CERTIFICATE OF APPROPRIATENESS

Property: 416 Euclid St, Lot 4, Block 12, Woodland Heights Subdivision. The property includes a historic 1,176 square foot one-story wood frame single-family residence and a detached garage situated on a 5,000 square foot (50' x 100') interior lot.

Proposal: Alteration – Addition

Recommendation: Denial - does not satisfy criteria 1, 4, 8, 9, & 10

WEST SIDE ELEVATION

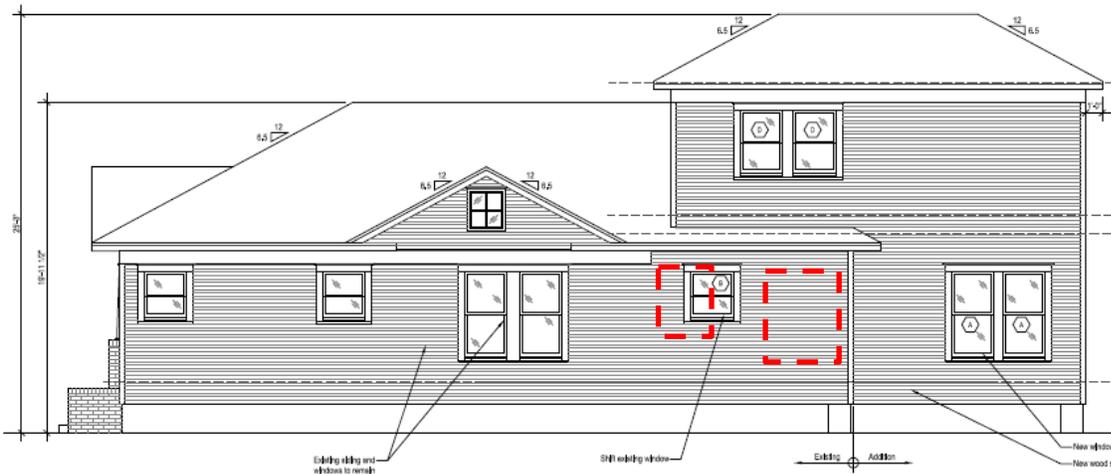
1 WINDOW SHIFTED TOWARDS THE REAR;
1 WINDOW REMOVED

Side Elevation: This elevation contains six 1-over-1 windows. The addition removes one window, shifts another over and contains four more 1-over-1 windows.
(West)
